STATEMENT OF HERMAN E. HURST, JR.
IN SUPPORT OF A
REPLY TO AN OPPOSITION TO A
PETITION TO DISMISS OR DENY
AN APPLICATION FOR A NEW FM BROADCAST STATION
AT PITTSBURGH, PENNSYLVANIA
FCC FILE NO. BPH-910628MC

Prepared For: EZ Communications, Inc.

STATEMENT OF HERMAN E. HURST, JR.
REPLY TO OPPOSITION TO
PETITION TO DISMISS OR DENY
PAGE 2

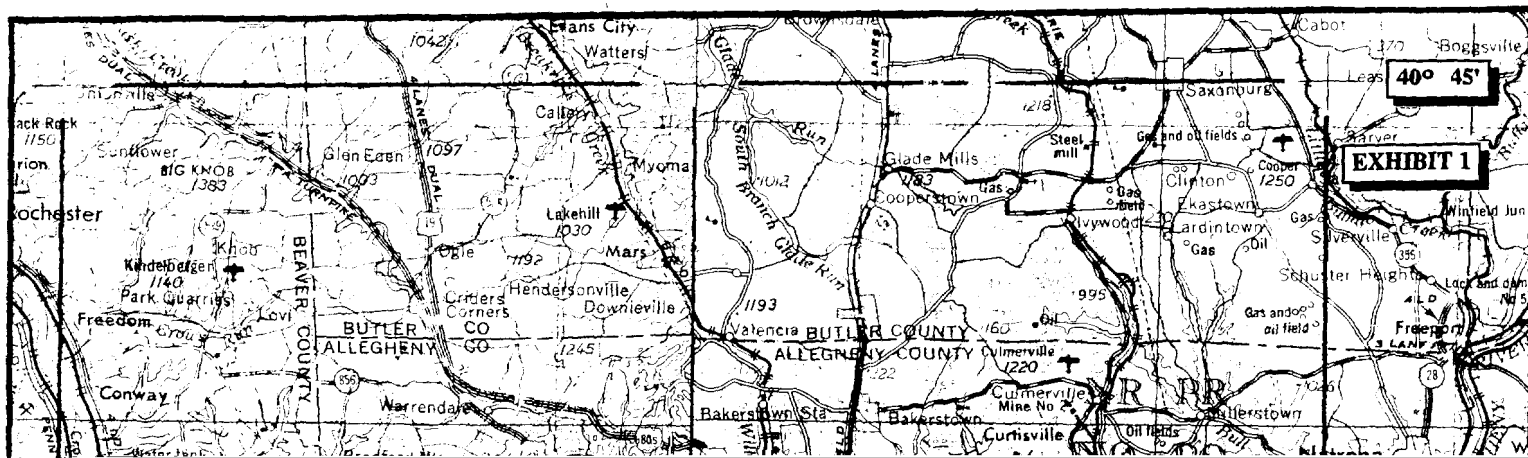
Moreover, ACGI has failed to recognize that a permissible site area exists in which the proposed transmitter site would have the ability to be fully-compliant with the FCC Rules and Regulations pertaining to contour protection. The Permissible Site Area is depicted on Exhibit 1, attached. With a reduction in its maximum ERP and a properly designed directional antenna, ACGI had the ability to protect WQIO, the potential first-adjacent Barnesboro facility, and WQIX pursuant to Section 73.215. Attached as Exhibit 2 is a tabulation of the directional antenna pattern (in relative field, based on a maximum
